184-D-013
City of Portland, Maine – Building or Use Permit Application 389 Congress Street, 04101, Tel: (207) 874-8703, FAX: 874-8716

DATE: 28/Aug/96 ADDRESS: 89 Montrose

REASON FOR PERMIT: INT. ALT.

87-89 Montrose St. Bathroom Remodel

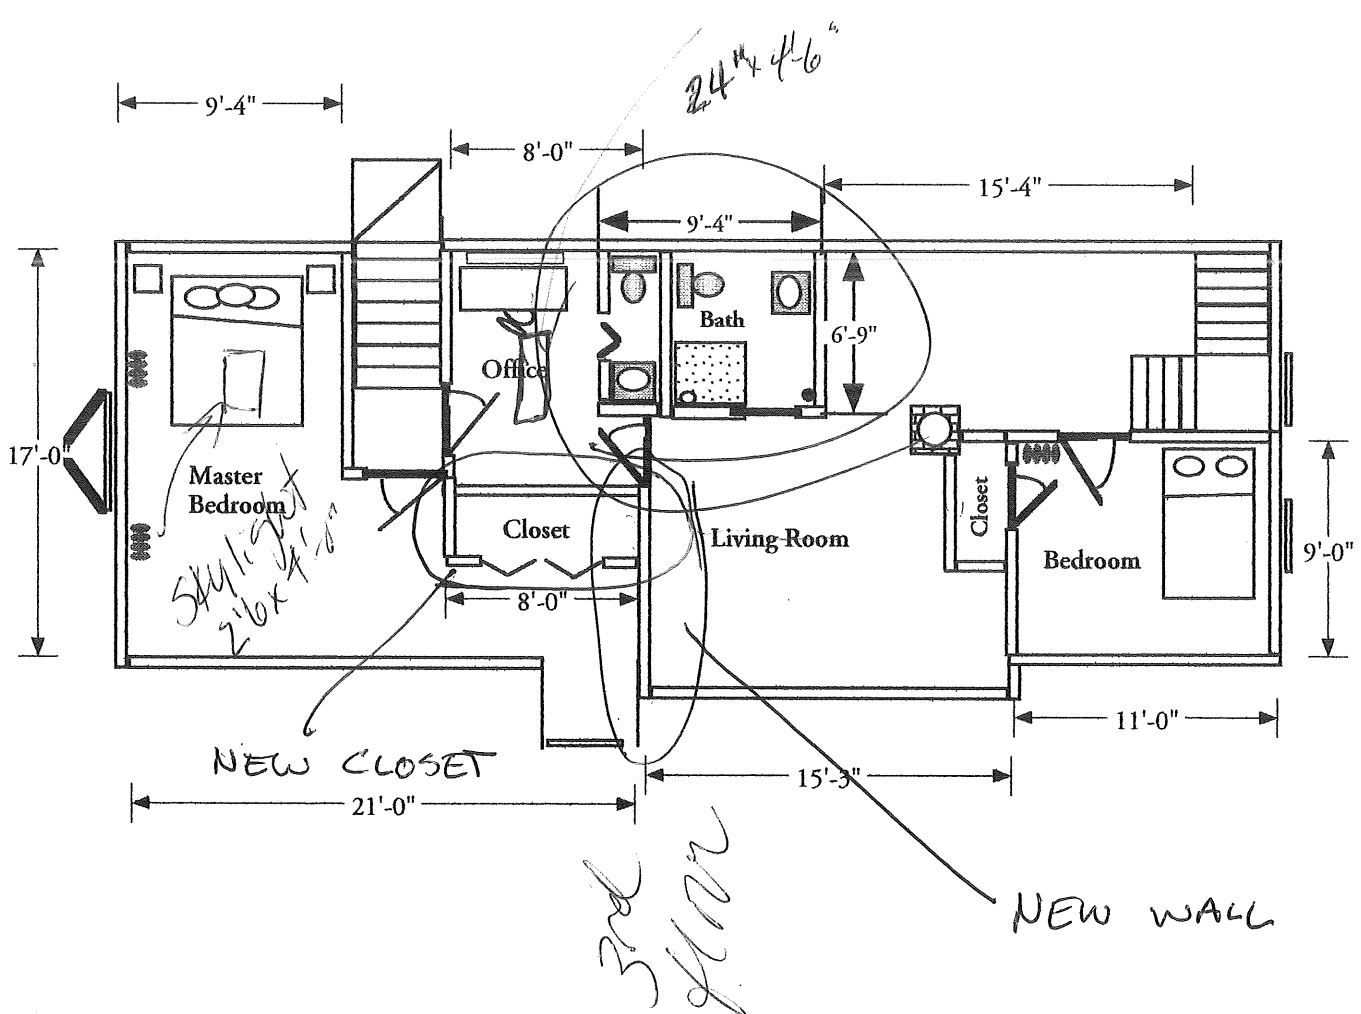
- All Studs 2x4 16" OC\
- Bedrooms are existing

ELECTRICAL + PLUMBING PERMITS TO BE
PULLED SEPARATELY -
